PARTS & SERVICE NEWS

REF NO.	AT00197A
DATE	Dec. 22, 2000
(C)	Page 1 of 12

SUBJECT: INTRODUCTION OF LOW OPERATOR COMPARTMENT NOISE SPEC. HD465/605-5

APPLICATION: HD465-5 Dump Trucks, Serial Nos. 4001 and up
HD605-5 Dump Trucks, Serial Nos. 1001 and up

Fig. 8 Drawing for installation of the plates (a bottom view)

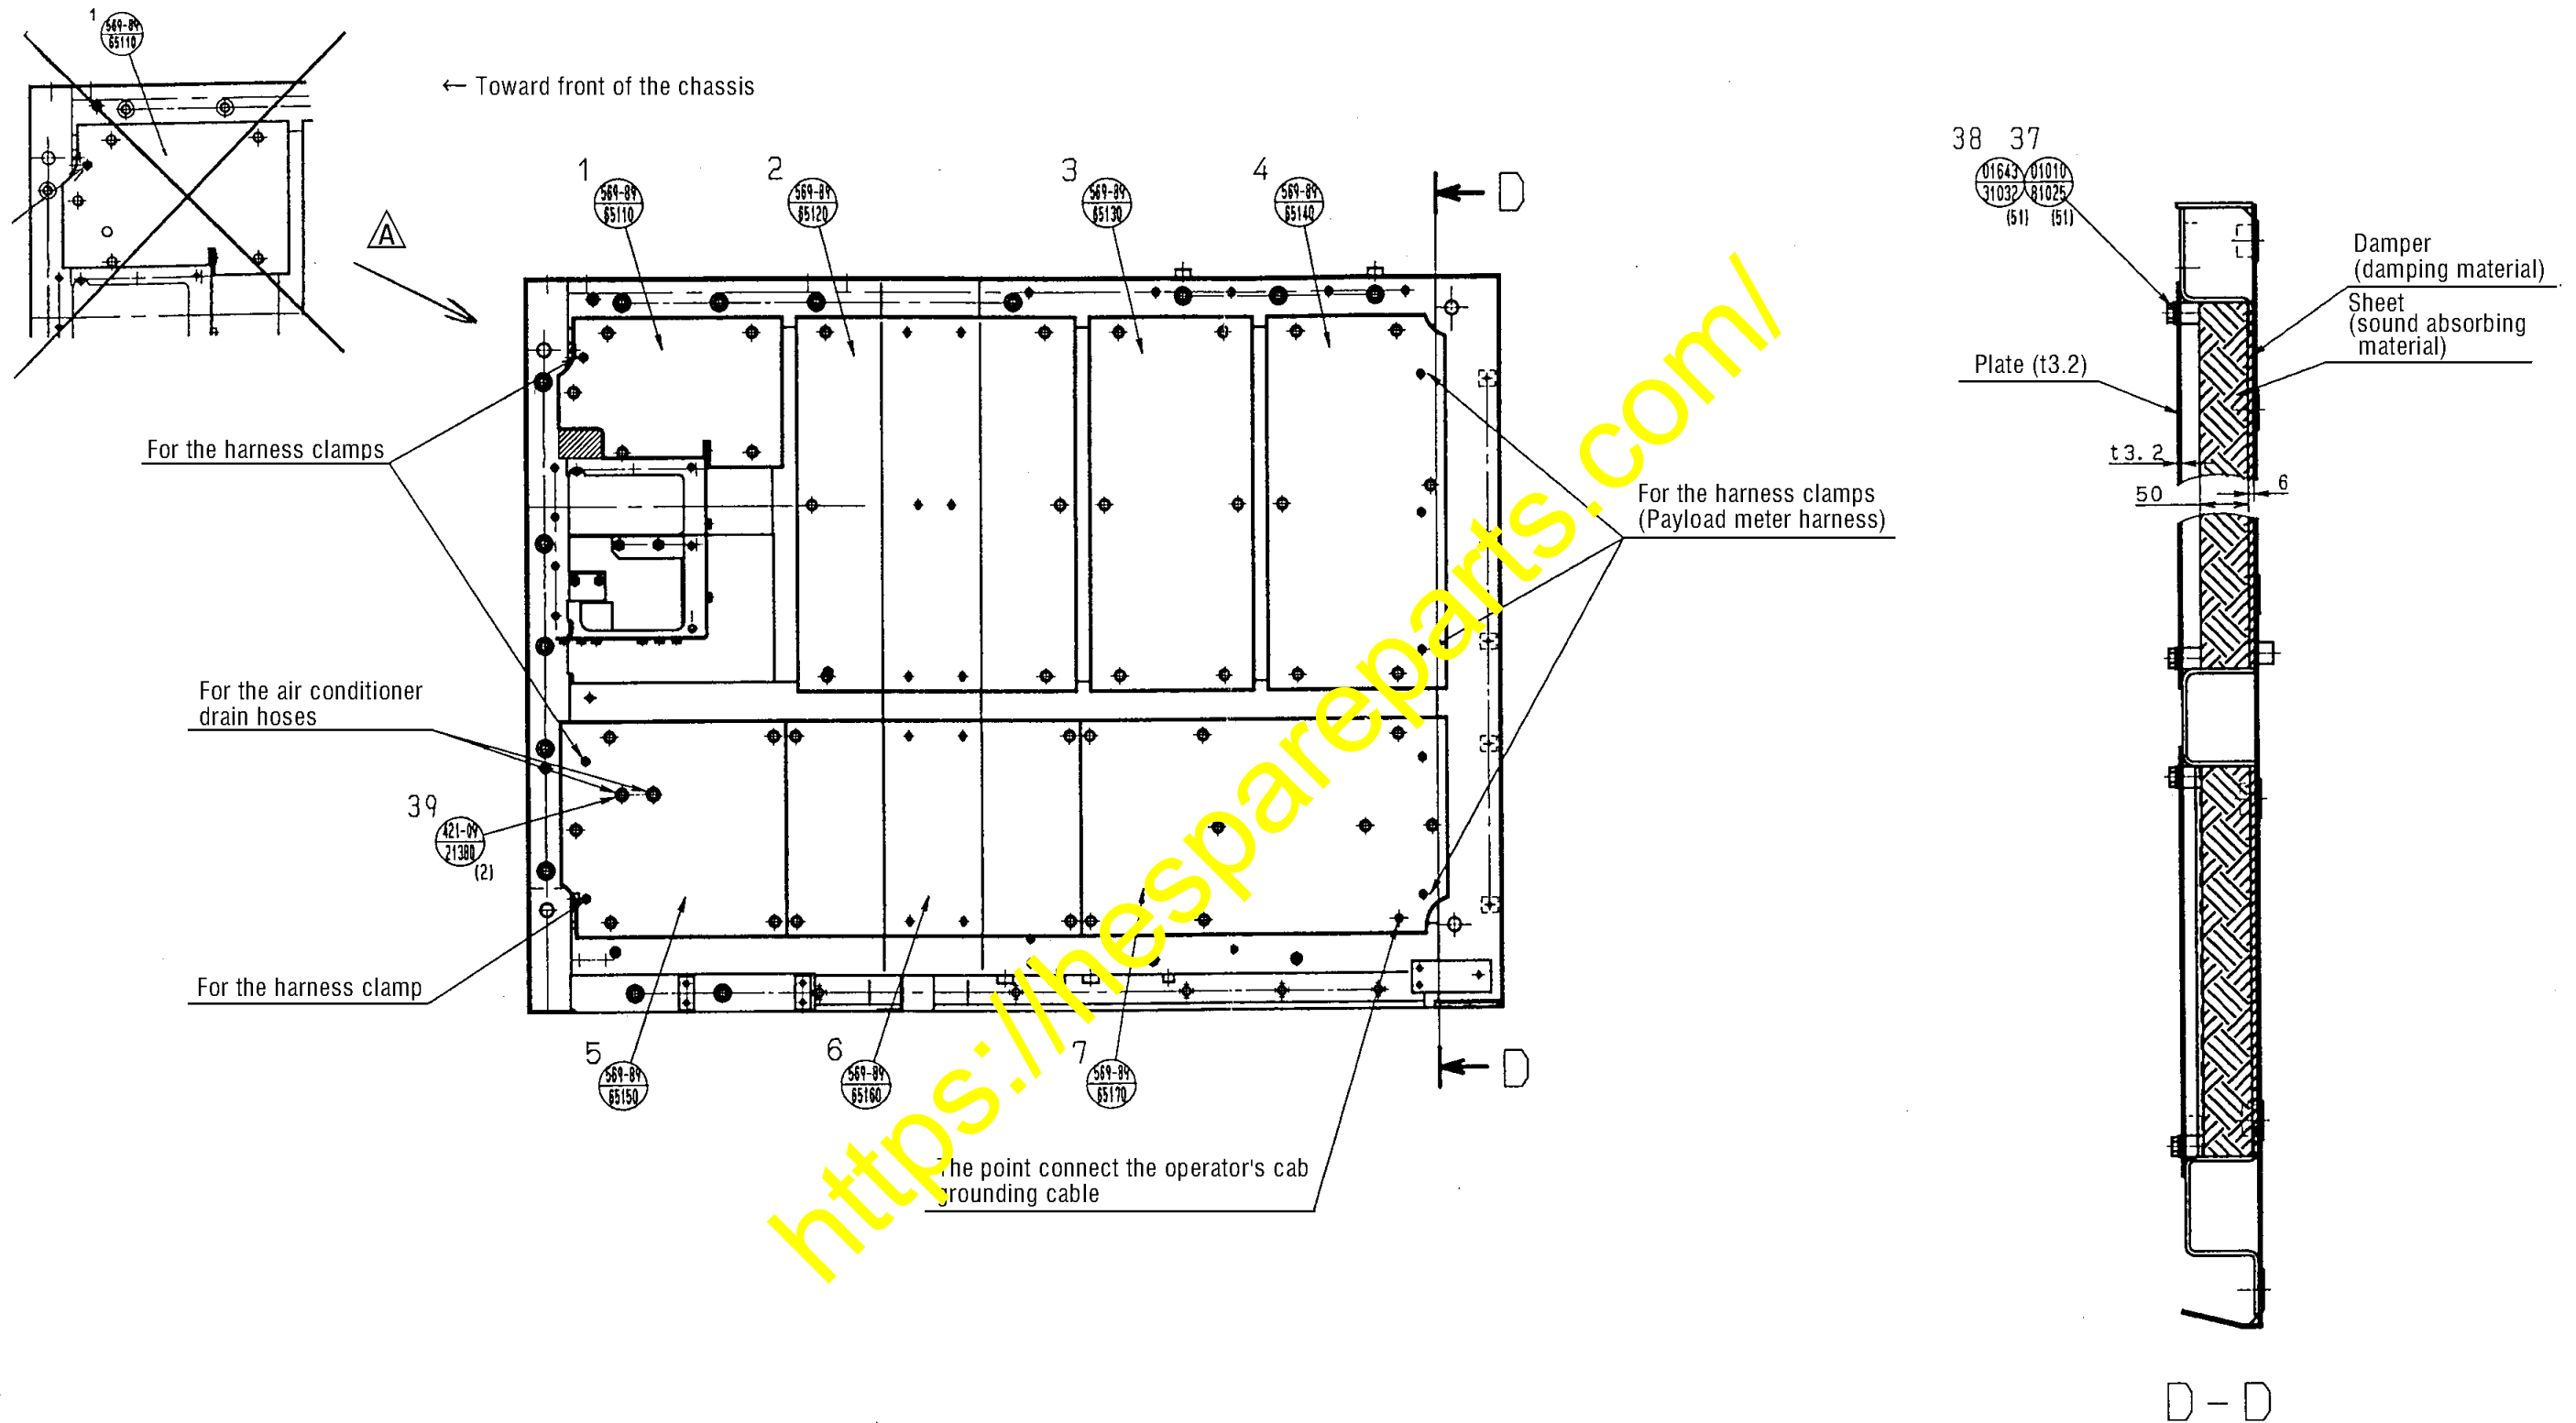
Install the plates ① through ⑦ onto the bottom surface of the operator's cab floor using bolts ⑳⑦ (01010-81025) and washers ㉑⑧ (01643-31032).

At this time, install the removed harness clips to the plate. Also, install the operator's cab grounding cable located in the rear section to the plate.

Fig. 9 Drawing for installation of the prepared parts onto the rear surface of the engine hood

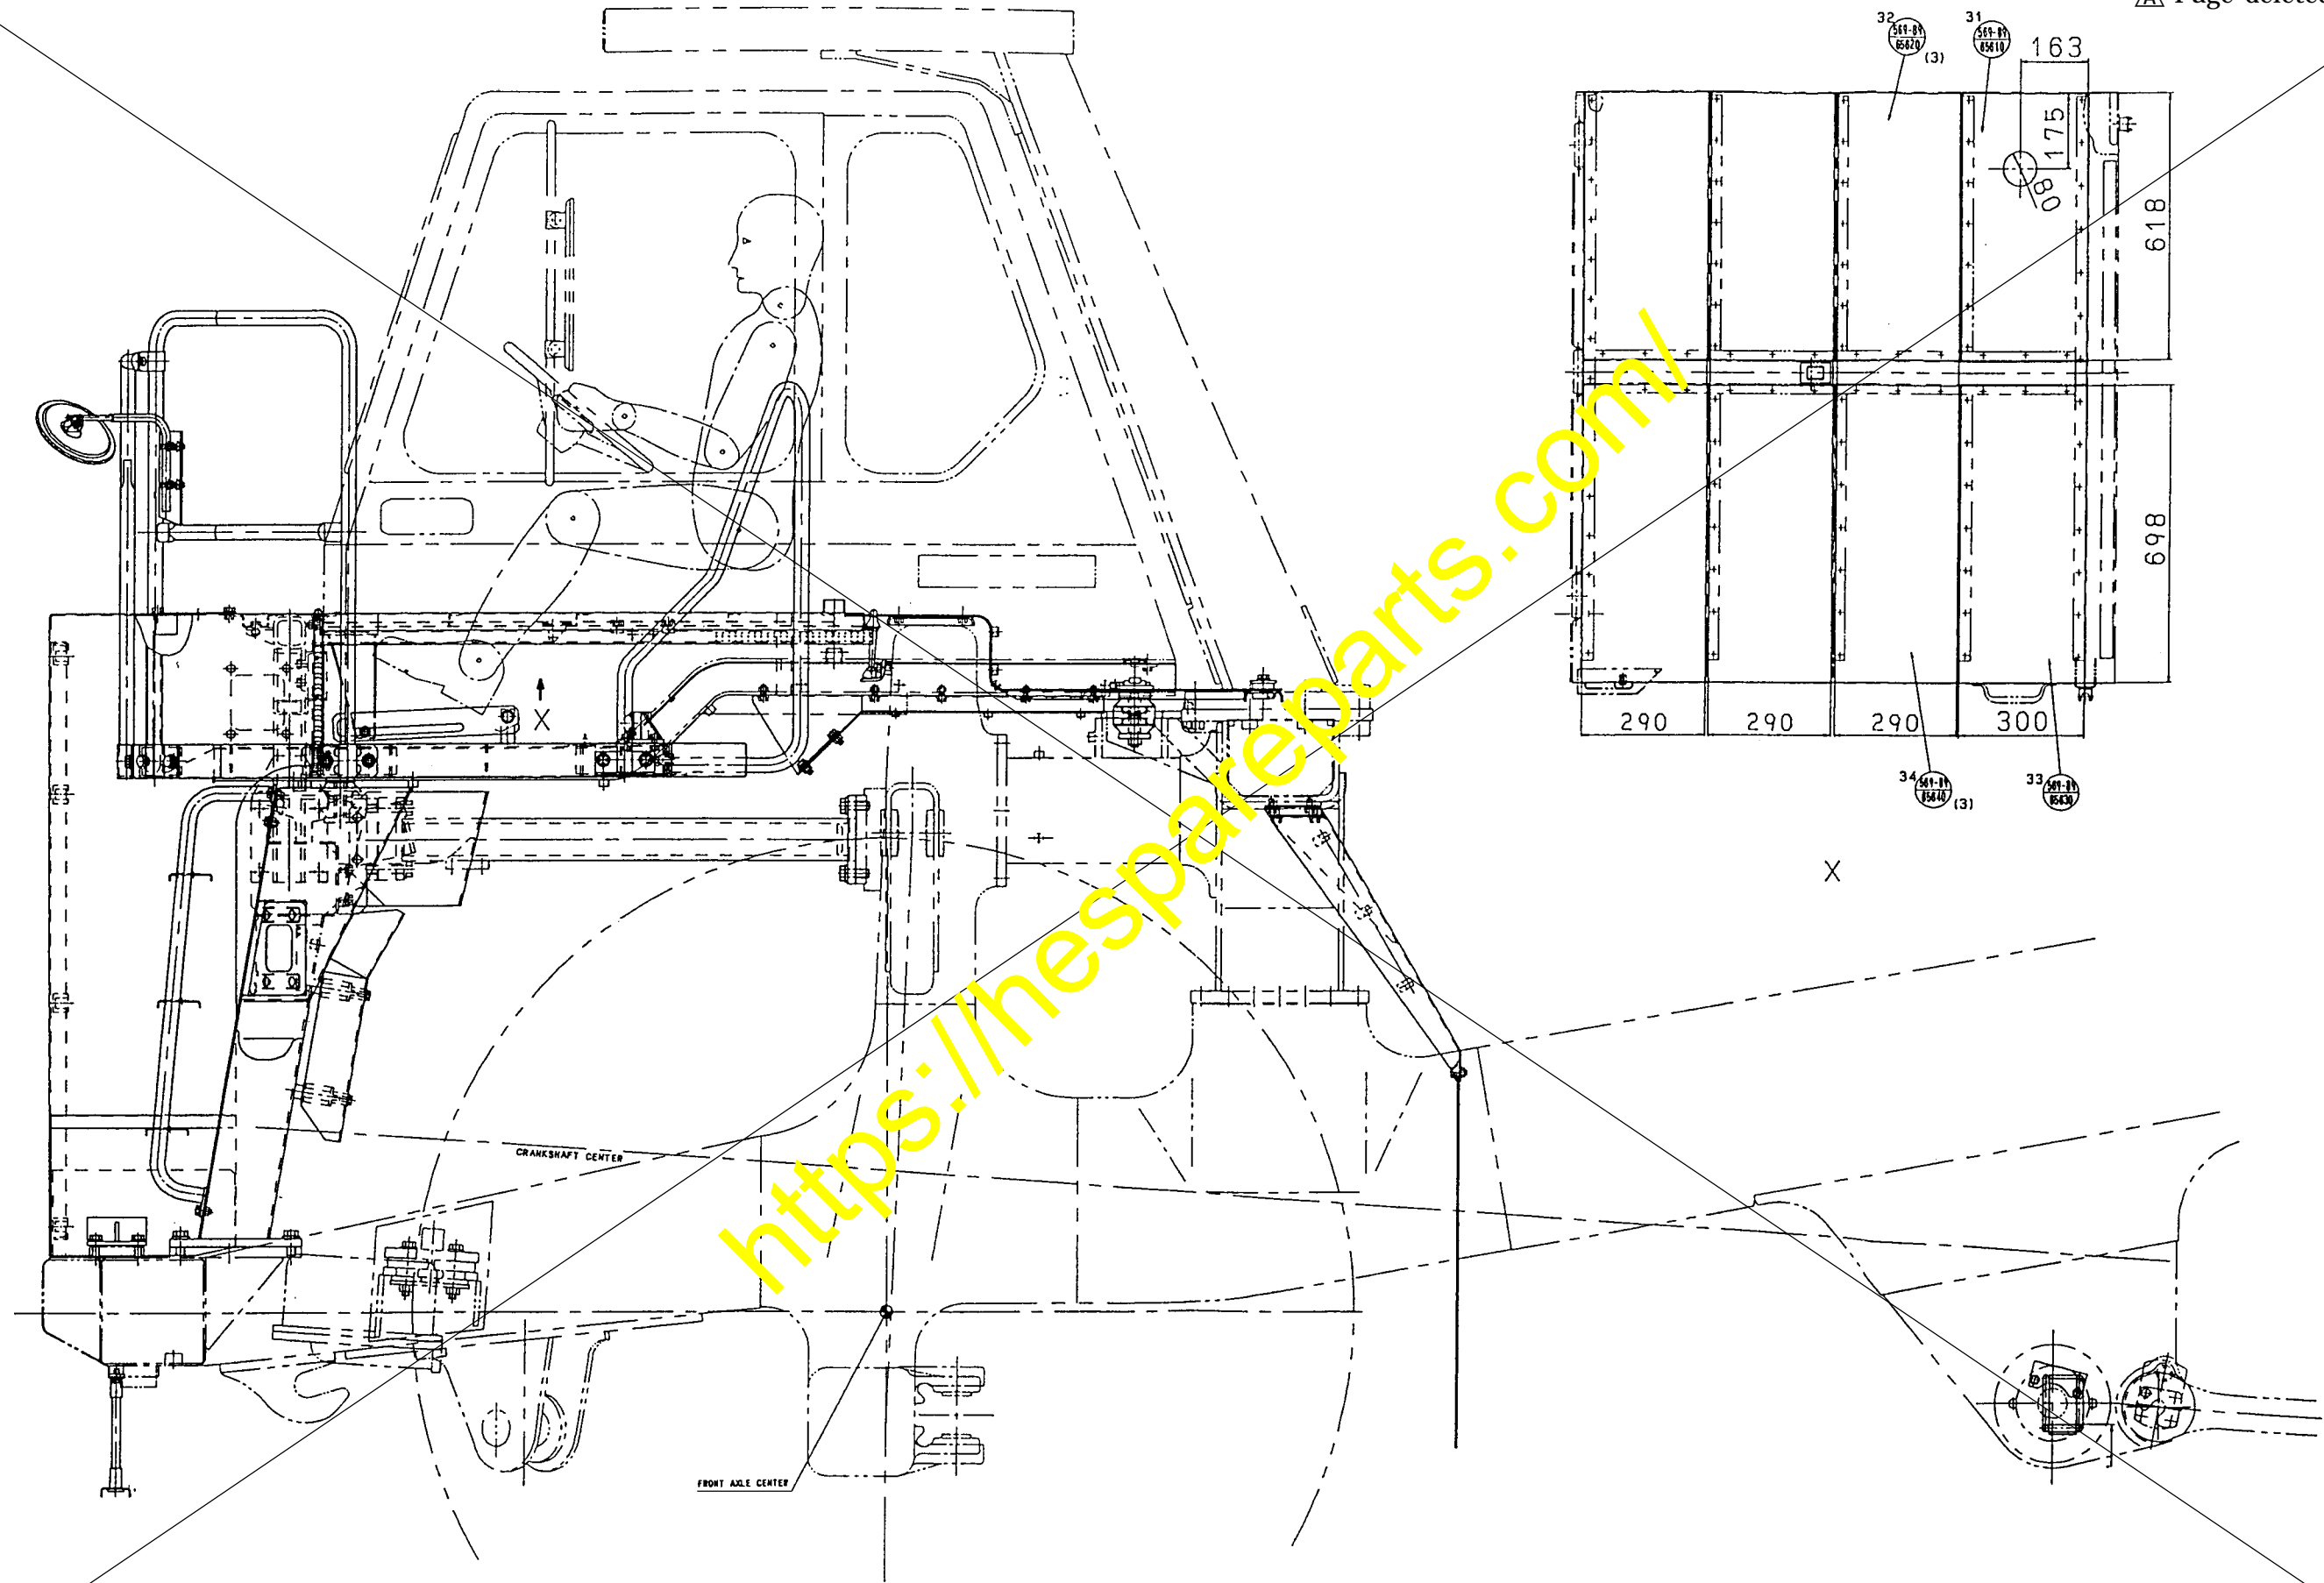
10 places 	Dec. 22, 2000	Addition of sound absorbing materials to the engine hood rear surface was cancelled.
---	---------------	--

~~ (2) Add the sound absorbing materials onto the rear surface of the engine hood~~

~~ (2) Installing the prepared parts onto the rear surface of the engine hood. (Refer to Fig. 9.)~~

~~Thoroughly clean the rear surface of the engine hood to completely remove mud and dirt.~~

~~Apply the sheets  thru  onto the rear surface of the engine hood. Since adhesive is being pre-applied onto one side of these sheets, remove the protection sheet before applying these sheets onto the rear surface of the engine hood.~~
